## SERVICE INFORMATION LETTER SI 01.03

Machines/Models: X series except X20N Serial Numbers: Above 15020

PURPOSE: Eliminate the battery drain when the E-stops and the key is left on overnight.

Figure 1

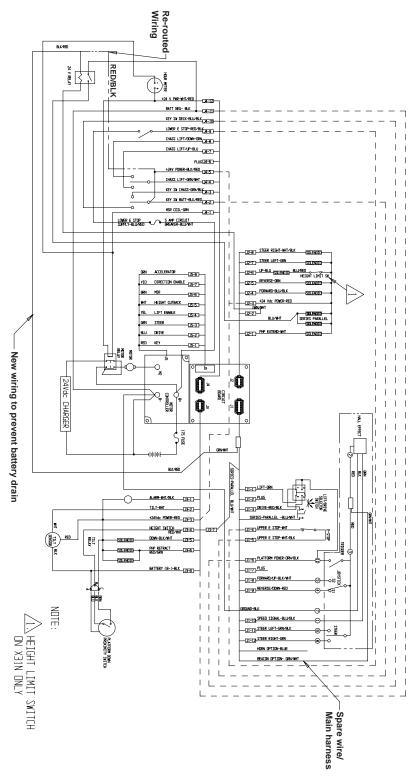
PROCEDURE REQUIRED: Make a wiring change at the upper and lower control box.

- 1. Disconnect the main battery cable from the battery.
- 2. Open the upper control box.
- 3. Locate the red wire that loops between pins 2 and 3 at the male side (machine side) of the joystick plug (see Figure 1).

- 4. Cut the red wire in the middle of the loop and strip both ends.
- 5. Locate the spare green/white wire in the main harness and strip the insulation from the end.

- 6. Using a 16-14 ga. butt splice, connect the two red and one green/white wire together (see Figure 1).
- 7. Close the upper control box.
- 8. Remove cover of lower control box.

- 9. Locate the black/red wire between the series/parallel relay and the key switch (see Figure 1).
- 10. Remove the black/red wire from the keyswitch.
- 11. Locate the spare green/white wire tied back in the main control harness.

- 12. Reposition the black/red wire adjacent to the spare green/white, cut, strip and using a
- 14-16 ga. butt splice, connect the black/red and green/white wire together (see Figure 1).
